1. David Scobie Architects

Under the report sections we comment:

Goulburn Performing Art Centre

A212 rev A

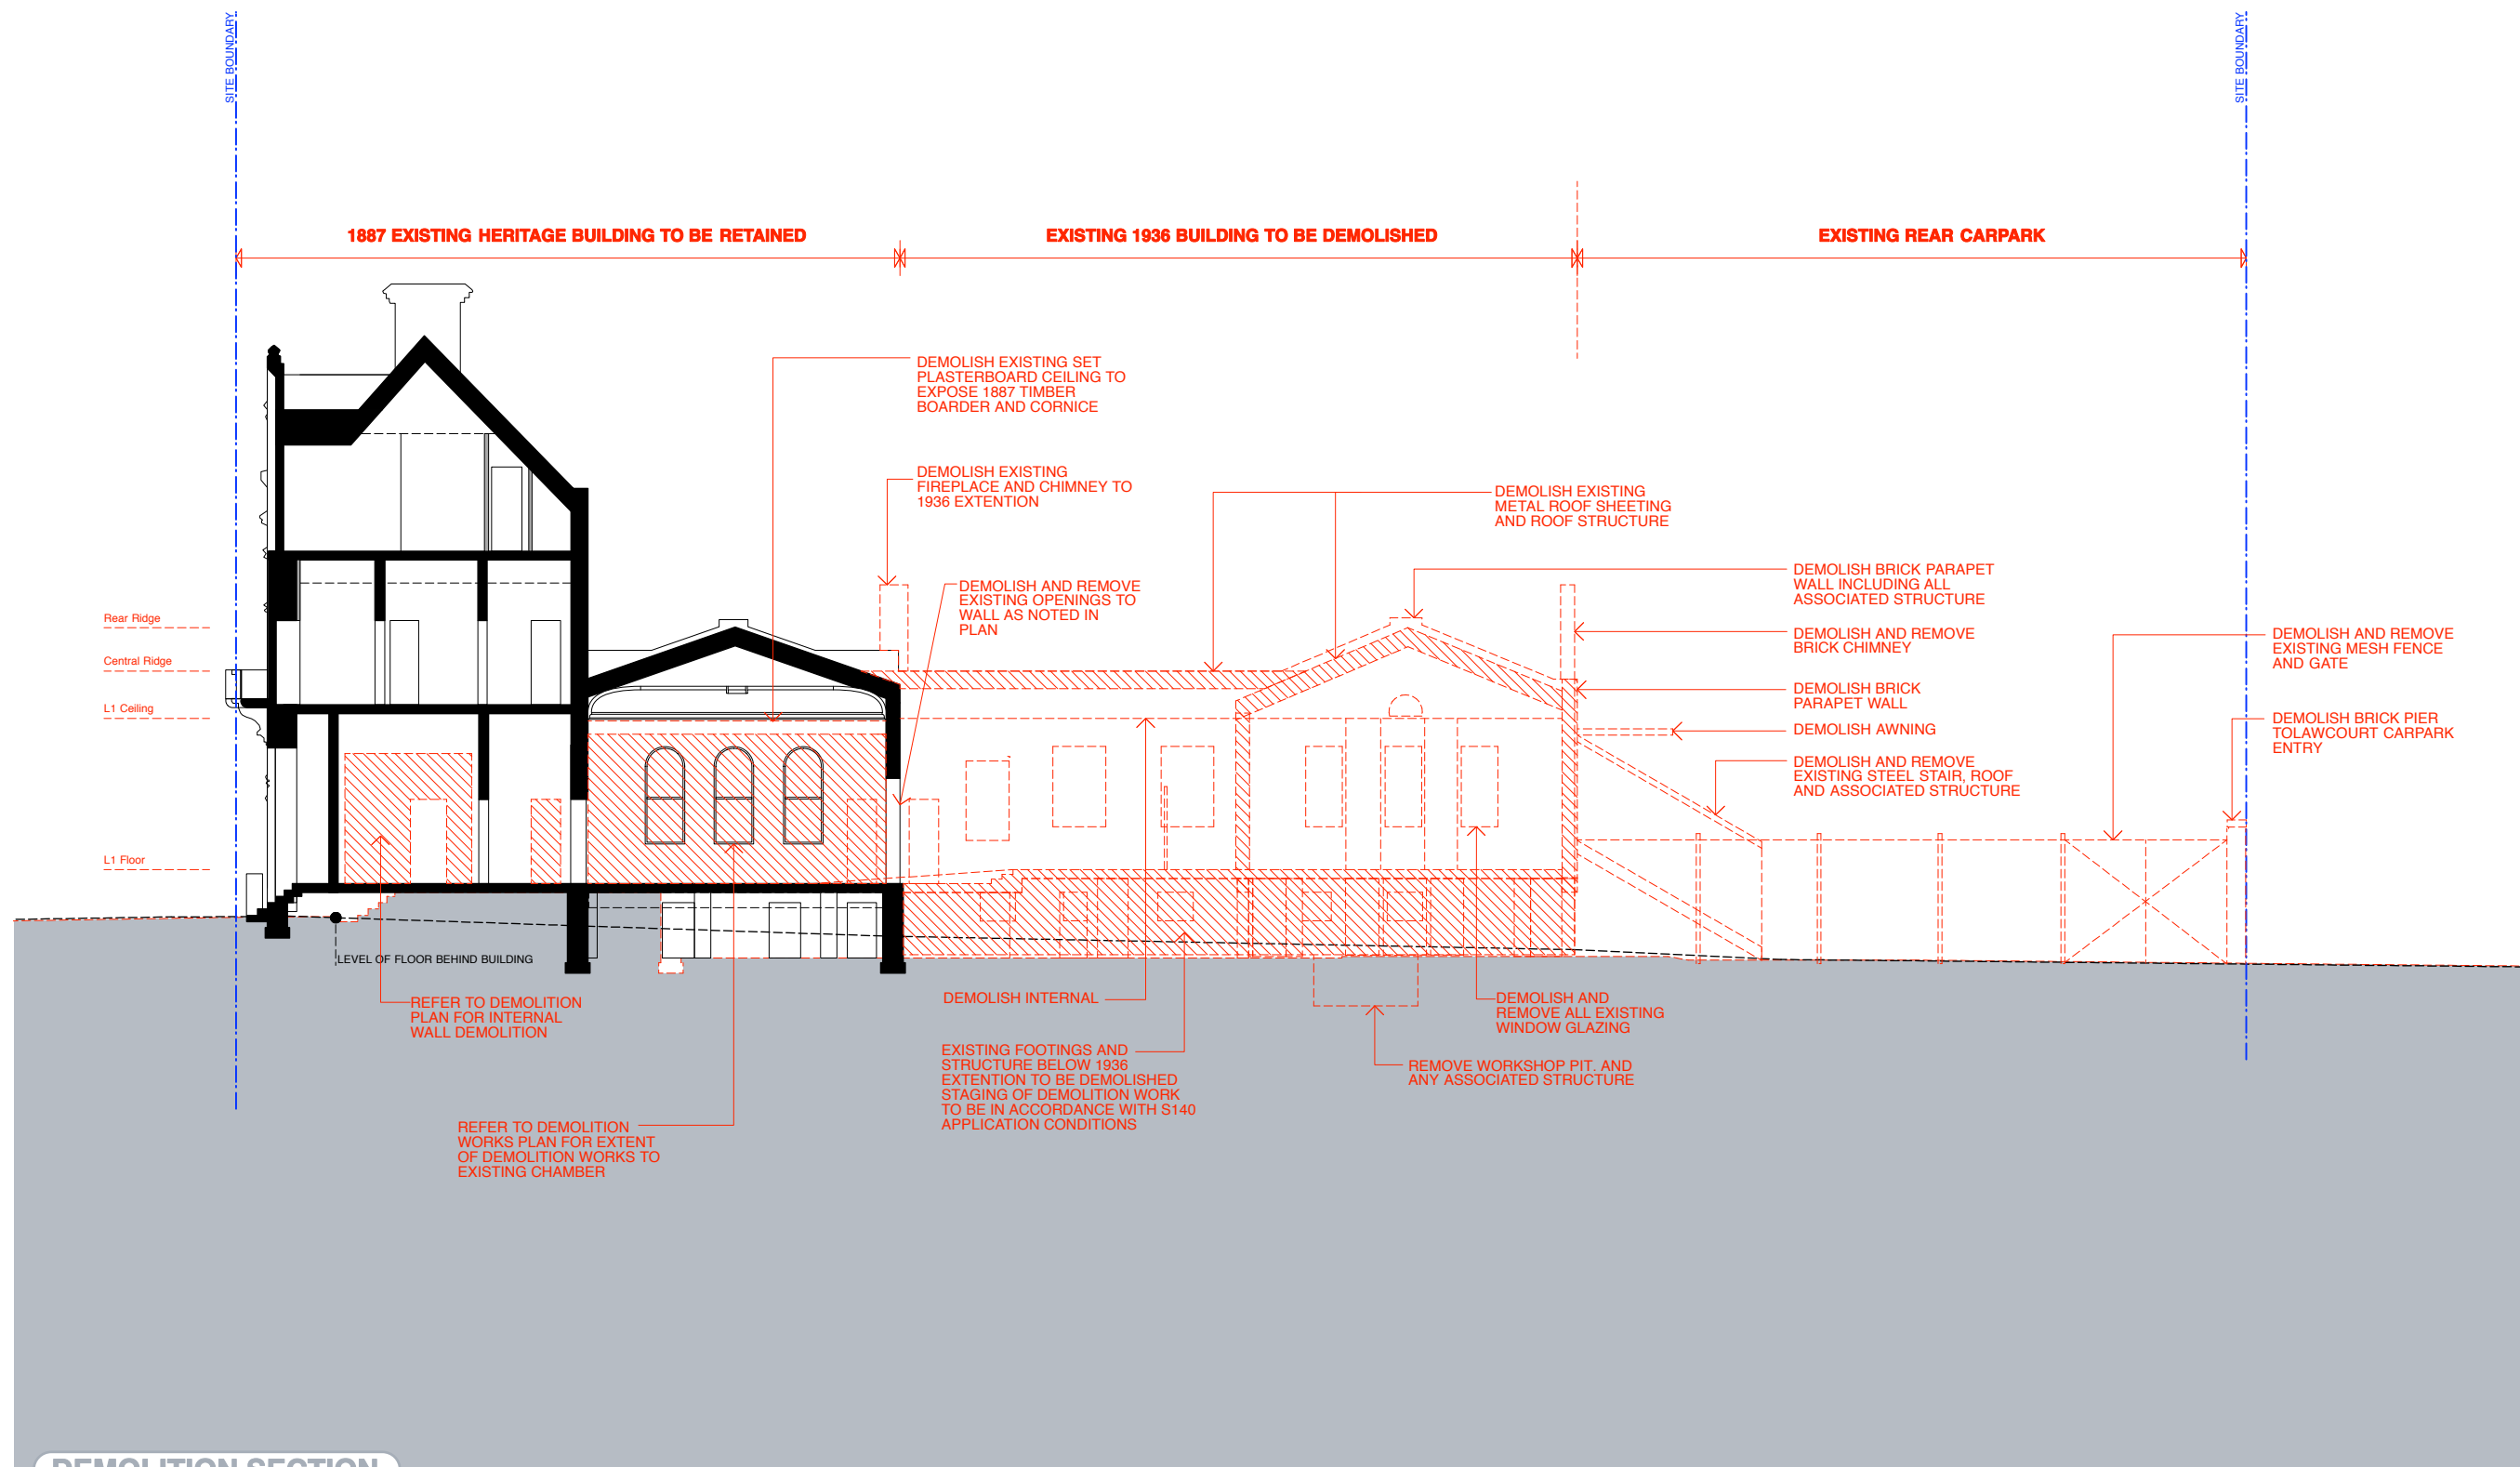
- Part demolition of the 1887 entry: as noted above the proposed openings to the existing entry foyer are more like enlargements rather than complete demolition of the walls, as per drawing Section 1. They will retain a head and nibs at each end to ensure mitigation as an understanding of the original configuration of the space. Although it does involve the removal of original fabric, the purpose is to ensure the functioning of the proposed Bar area as a contemporary use, not only accessible from the street, but readily visible as an open public area.
